MILITARY SPECIFICATION

RECEIVING SET, LORAN AN/ARN-78

This amendment forms a part of Military Specification
MIL-R-38327B(USAF) dated 23 February 1966.

FIGURE 5. RECEIVER, LORAN R-1298A/ARN-78

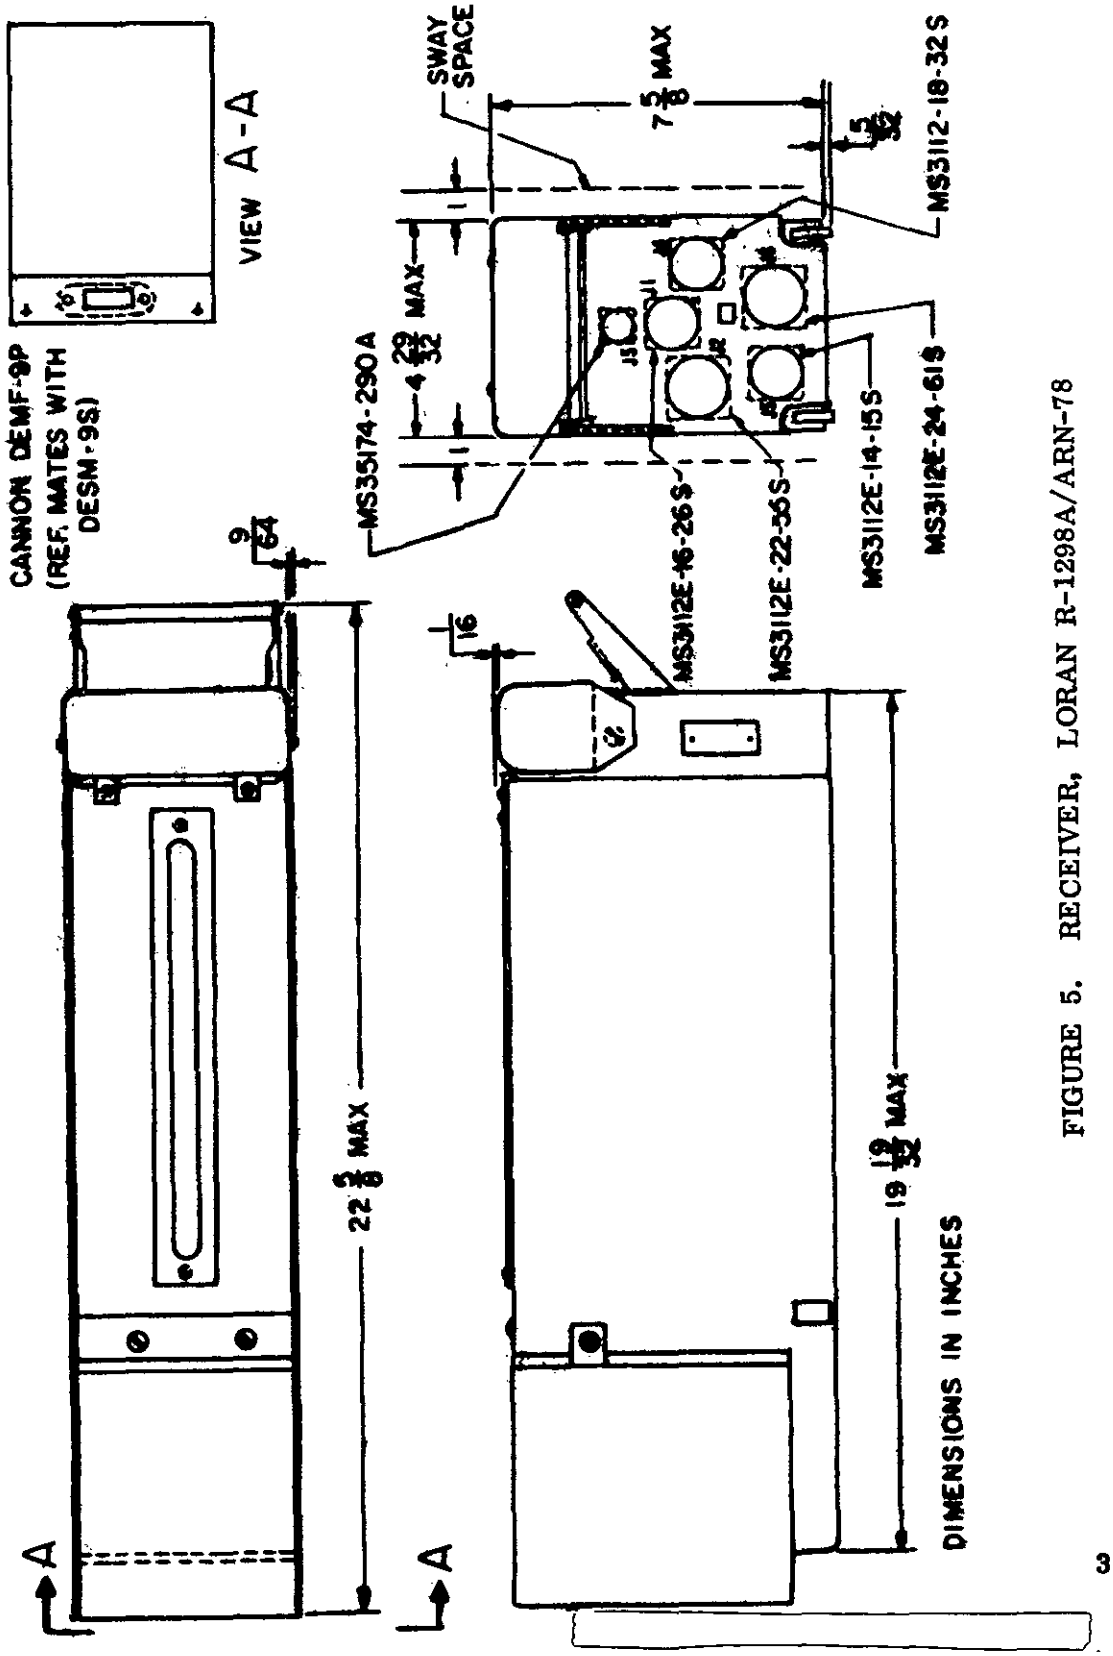
Page 19, figure 5: Delete and substitute the attached figure 5. Figure 5 forms page 3 of this amendment.
